# Memo

**Re:** Consultation on an Application

**Planning Application Ref:** PL/26/0372

**Proposal:** Application for approval of details reserved by conditions 1, 2, 3, 4, 6, 7, 8, 9, 10, 11, 12, 13, 14, 15, 16 and 17 of application PL/25/0273

Landscape Plan Diagram (Rev B)

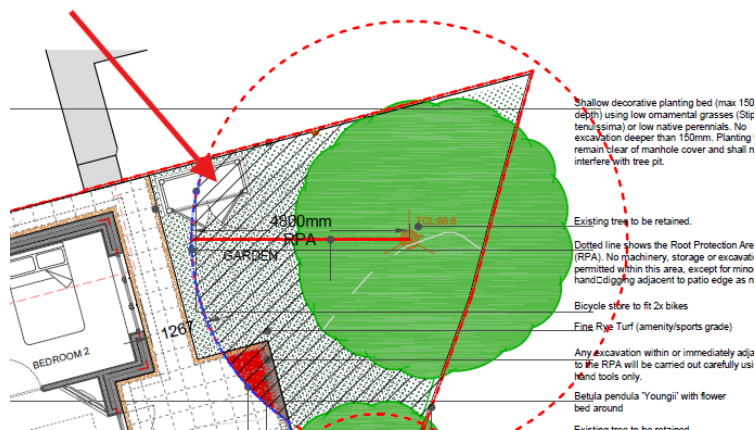
I note that the 'Existing trees to be retained' label only points to one of the trees on site. There is another tree in the southeastern corner, and it is not clear whether this is to be retained or removed. Clarity needs to be provided on this as development must not lead to a net loss in tree numbers. This information should have been demonstrated at the application stage. Section 3.2 Retained Trees of the Landscape Specification, states 'Protect all trees marked Existing trees to be retained', but it is unclear how the trees will be protected as no RPAs are shown on the Landscape Plan and there is no tree protection shown. With reference to the Construction Method Statement, Ref: PL/A724/D04, I note that tree protection isn't shown here either. I also note that the site office appears to conflict with the tree in the southeastern corner (that is not clearly labelled as retained), so clarity must be sought on this as this may require tree removal or facilitative pruning.

With reference to the PROPOSED SITE PLAN HARD & SOFT LANDSCAPE LAYOUT, March 2026, Drawing No. PL/A724/07, Rev: B, I note that the bike sheds are being constructed partially within an RPA. I encourage that these are built above ground level and excavation is minimised through the use of a foundation type such as screw piles. I also encourage that a gap between the base of the bike sheds and the ground is left to allow for water permeability/movement and gaseous exchange within the soil of an RPA. If any concrete is poured into the ground, I encourage impermeable liners are used within RPAs to prevent the concrete leaching into the soil. If any excavation is required to facilitate the construction of the bike sheds within an RPA, the methodology in Section 2. Existing Trees & Retention Strategy, should be followed.

I note the 'Proposed mixed hedge planting to screen north and east boundaries for private amenity space' doesn't state the species or provide any further detail within the Landscape Specification. This is not detailed enough to meet the requirements of the condition. It needs to specify species, planting sizes, spacing and numbers of plants to be planted.

I note the hedge planting on the frontage of the site is '*Photinia Red Robin Hedging Plants 20-30cm Bushy Evergreen Hedge Shrubs*'. Section 5.2 *Photinia Red Robin Hedge* of the Landscape Specification then provides further detail on this. However, the maintenance and planting requirements are not detailed enough i.e. all planting should be undertaken during the planting season (stating the months) and there should be a detailed ongoing maintenance programme in order to determine successful establishment over the course of five years, as with all the planting on the site.

I note there is a new *Betula pendula* 'Youngii' proposed to be planted on the frontage. Section 5.4 *Betula pendula* 'Youngii' Tree of the Landscape Specification details the planting of this further. Whilst this is positive, it does not include a tree pit specification or the stock size of the tree, which needs to be provided in order to meet with the requirements of the condition. I also note that it states it will be planted within a flower bed. The species of flowers and other information regarding these plants and their maintenance have not been provided.

With reference to the LANDSCAPE SPECIFICATION (PL/A724/D03A – Landscape Specifications REV A), it has now been confirmed that the two trees in the rear garden will be retained and protective measures will be implemented in accordance with the BS5837 2012, which is positive.

This hedging in the rear garden has been omitted with the two existing trees retained. Section 5.1 Hedge Species Mix (Native), 5.2 Planting Specification & 5.3 Planting Arrangement, now provides species, spacing and sizes which is positive. A final total number of plants should also be stated. The only hedging now shown is that on the frontage along the southern boundary and a small section on the western boundary (previously further hedging shown on the frontage adjacent to the proposed tree), which Ecology will need to provide further comments on.

This has now been omitted from the plans which is negative as this reduces the amount of soft landscaping. However, I do acknowledge that the two trees in the rear garden are both being retained and that a mixed native hedge is replacing some of the previously proposed hedging. It is unclear why the hedging adjacent to the newly proposed tree on the frontage has been omitted (being previously '*Photinia Red Robin Hedging Plants*') but not replaced with mixed native hedging, so clarity would be welcome. An additional mixed native hedge on the frontage could mitigate for that lost in the rear garden, but I will leave Ecology to comment further on this.

I note the stock size has been provided but only states girth. Planting should state both the girth and height of the time of planting.

I note a tree pit diagram/cross section has not been provided. I advise that the latest guidance for tree planting/pits is referred to, being the BS8545:2014+A1:2026 'Trees from nursery to independence in the landscape – Code of practice'. Trees of different stock sizes have different tree pit specifications; hence the tree pit should be designed specifically for a 10-12cm in girth tree.

Landscape Plan (Rev B) Vs Google StreetView

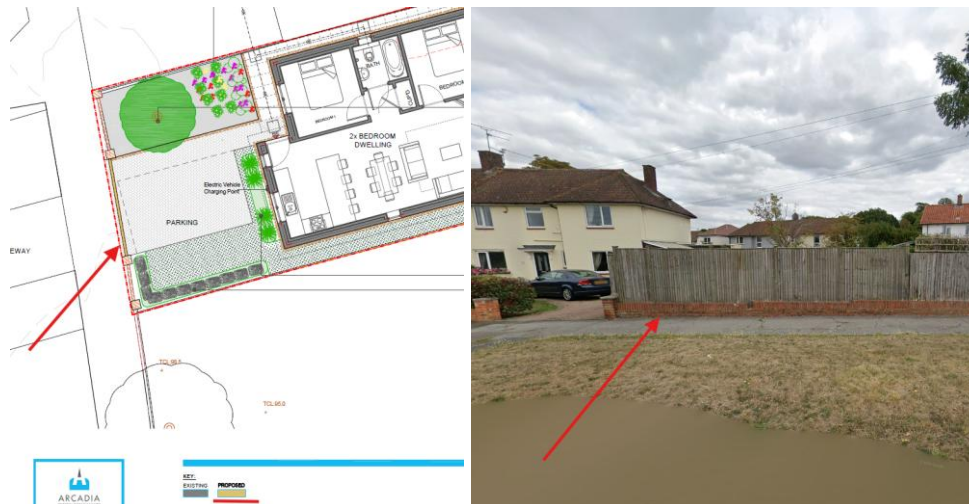
The Landscape Plan states that the southern boundary fence will retain the existing fence which is fine. The northern boundary treatment has been stated using both a '*Minimum 1.8m high close boarded fence*' and a '*Proposed 2m high close boarded fence*', but it isn't clearly indicated where these different boundary treatments change/the extent of each different boundary treatment.

Section 5.4 Boundary Treatment states '*Existing close-boarded fence retained*' on the western boundary. However, the fencing will need to be altered to allow for the parking/driveway entrance hence this should be demonstrated. There also appears to be an existing brick wall which is not acknowledged in the existing boundary treatment, and it is not clear how this wall will need to be adjusted to facilitate the driveway. Will there be a new gate for the driveway or is it being left as an open entrance? The Landscape Plan seems to be proposing something new as the key indicates.
